Manuscript ID: ESSD-2025-304

Title: Ice front positions for Greenland glaciers (2002–2021): a spatially extensive seasonal record and benchmark dataset for algorithm validation

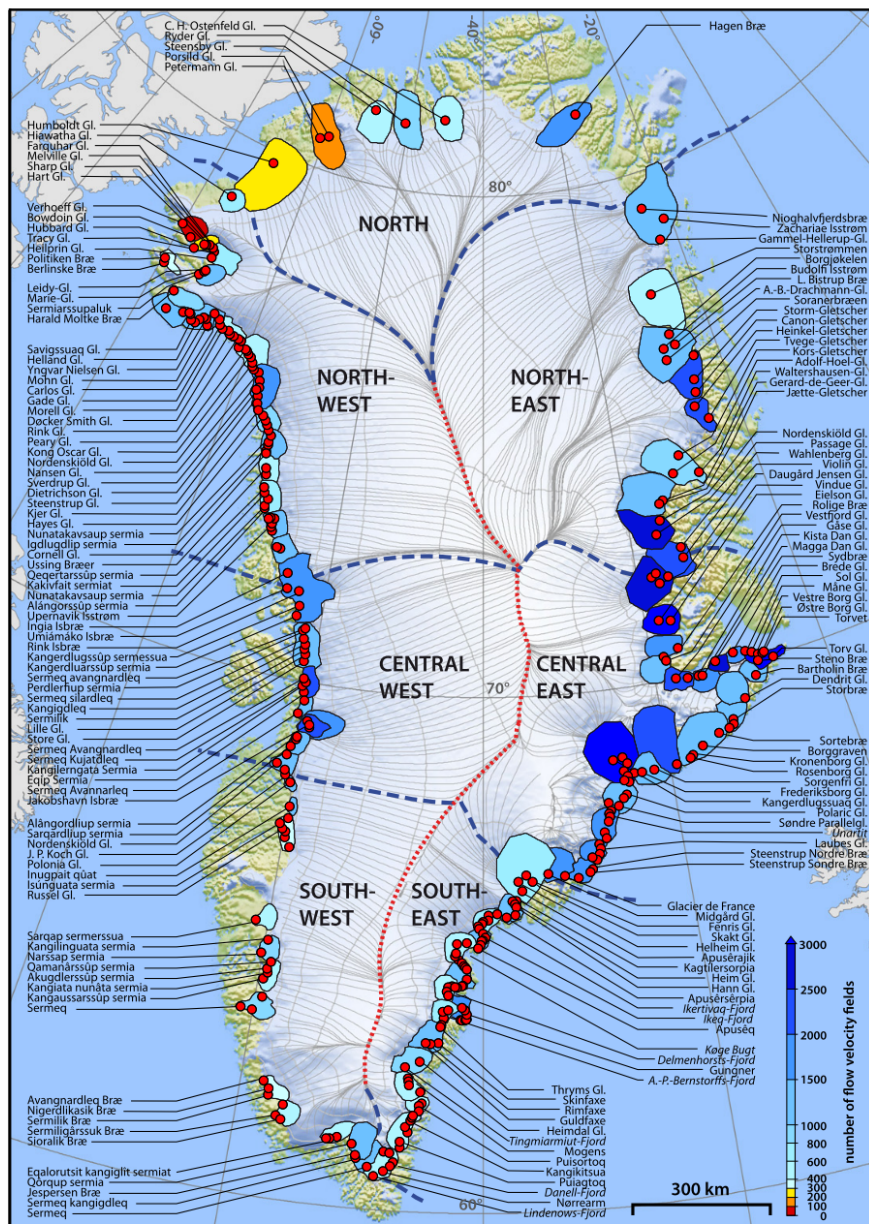
8. **Figure 1** –Please use the full names of the glaciers (e.g. Petermann Glacier, Jakobshavn Isbræ), check the spelling (e.g. Isstrøm) and be consistent (Gletscher vs Glacier). Panels should be labelled from A) overview map to G) Kangilinguata Sermia. Also "Sermia" should be spelled with a captial "S". This glacier is also not marine-terminating as is clearly visible in the image which contradicts previous statements that the dataset is looking at marine-terminating glaciers.

Response: As noted previously, all glacier names will be corrected and standardized according to map from NunaGIS and Bjørk et al. (2015). In addition, since the revised dataset will include both marine- and non-marine-terminating glaciers, the related descriptions in the text will be updated to avoid implying an exclusive focus on marine-terminating glaciers.

Fig.2 Seasonal sampling examples from the TermPicks dataset for Graae Gletscher (116), Heinkel Gletscher (109), and Humboldt Gletsjer (85) (Goliber et al., 2022).

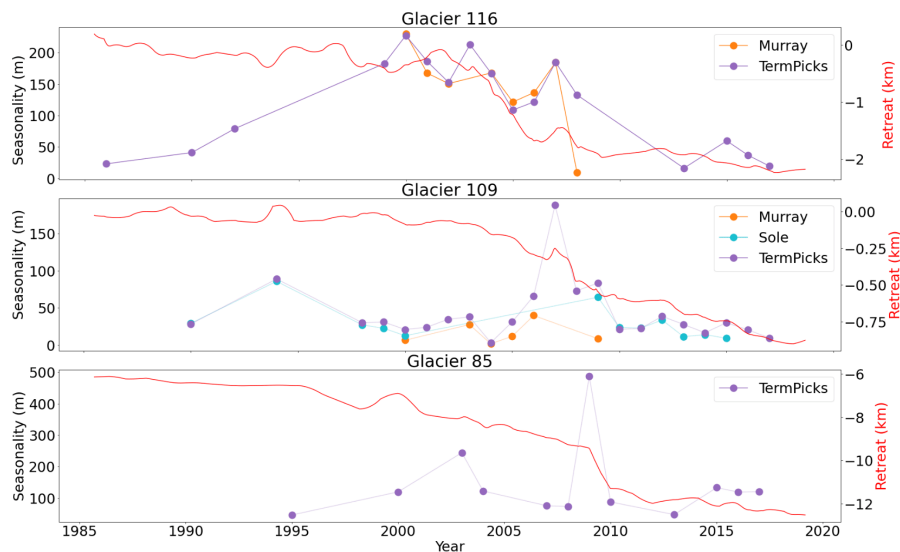
37. L286–287 –From the figures in the manuscript, I struggle to see the increased spatial and temporal coverage compared to TermPicks. If anything, the dataset presented here seems to have less temporal coverage than existing datasets (e.g. Figure 7).

Response: The original spatial-coverage statistics were based on the total number of delineated glaciers, which exceed the glacier number of existing products. As noted above, we are refining the dataset’s classification and expanding it to explicitly include more marine-, land-, lake-terminating, and floating-tongue glaciers. Once the updated dataset is completed, the total and marine- terminating glacier count will further increase. The corresponding figure will be revised and annotated to reflect the expanded coverage.

TermPicks and our datasets differ in scope and objectives, and they are complementary in terms of their spatial representation and temporal characteristics. Regarding TermPicks, we agree that it provides excellent long-term temporal coverage for marine-terminating glaciers. Our dataset, however, has a broader scope, encompassing marine-, land-, and lake-terminating glaciers, and this coverage will be further expanded in the revised version. Our product is specifically designed to capture seasonal variability in calving-front positions. In the current version, most glaciers achieve at least two observations per year across the study period, and additional scenes are being incorporated to further enhance seasonal completeness. By contrast, TermPicks integrates results from multiple studies with varying temporal sampling. Its seasonal sampling reflects the availability of the underlying source datasets and therefore covers only a subset of glaciers and time periods, with variability among individual glaciers (Fig.2, Goliber et al. (2022)).

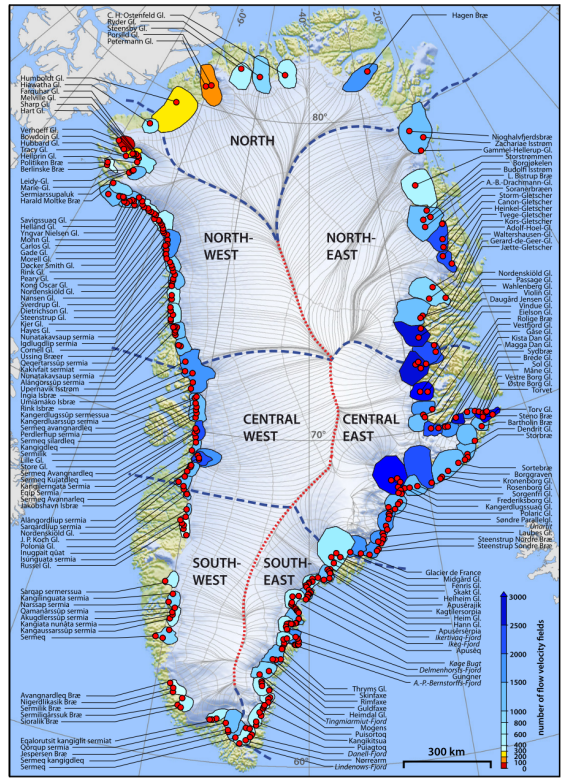
At various points in the paper (e.g. lines 19 and 78), it is emphasised that this data product has complete and consistent temporal sampling. This would be a major advantage, particularly for diversifying reference data for machine learning approaches, as most other manually delineated products have heterogeneous sampling, as they are usually by-products of focused glaciology studies. However, Figure 9 shows that the sampling is inconsistent. At L317, it is also stated that glaciers of higher scientific

This description was originally based on the scope of the dataset at the time of submission. In addition to supporting automated calving-front detection, our broader objective was to develop a dataset suitable for large-scale investigations of the seasonal behaviour of Greenland outlet glaciers, including joint analyses with seasonal velocity products derived from Landsat imagery over the past few decades. Accordingly, we used the spatial extent of glaciers covered by Landsat-based seasonal velocity fields as our selection criterion (Fig.1, Rosenau et al. (2015)). Glaciers outside this extent were assumed to exhibit limited frontal variability and were therefore not included. Within this defined spatial domain, our dataset effectively covers the glaciers (~290 compared to the 302 included in Rosenau et al. (2015), with some low-quality cases removed) for which seasonal velocity variations can be reliably detected.

Fig.2 Seasonal sampling examples from the TermPicks dataset for Graae Gletscher (116), Heinkel Gletscher (109), and Humboldt Gletsjer (85) (Goliber et al., 2022).

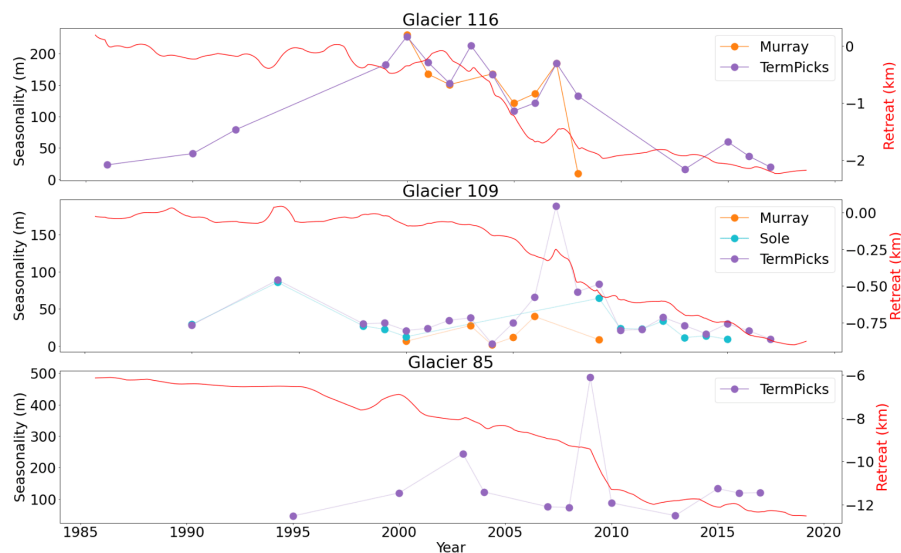
Data quality and validation. This is the most critical point, in my opinion. The authors report an accuracy range of 40 to 100 metres for this data product. This value is derived by comparing the calving fronts in 15 satellite images across five glaciers to delineations from other data products. This is supplemented by visual comparisons against Planet imagery for another six calving fronts, as well as visual comparisons of five calving front change time series with other products.

Response: We agree that the analysis based on the six representative glaciers in the initial submission was insufficient to fully justify the reported accuracy range. This limitation primarily arose from the difficulty of identifying overlapping same-day observations for the same glacier across datasets. The originally reported accuracy range of 40–100 m was therefore derived from a small number of available sites and will be updated— and made more robust— once the dataset supplementation and comprehensive cross-validation are completed. Nevertheless, the initial results already indicate that our manual delineations are generally more reliable than automated products, particularly along complex glacier margins.

The two datasets differ in scope and objectives, but they are complementary in terms of their spatial representation and temporal characteristics. Regarding TermPicks, we agree that it provides excellent long-term temporal coverage for marine-terminating glaciers. Our dataset, however, has a broader scope, encompassing marine-, land-, and lake-terminating glaciers, and this coverage will be further expanded in the revised version. In addition, our product is specifically designed to capture seasonal variability in calving-front positions. In the current version, most glaciers achieve at least two observations per year

across the study period, and additional scenes are being incorporated to further enhance seasonal completeness. By contrast, TermPicks integrates results from multiple studies with varying temporal sampling. Its seasonal sampling reflects the availability of the underlying source datasets and therefore covers only a subset of glaciers and time periods, with variability among individual glaciers (Fig.2, Goliber et al. (2022)).
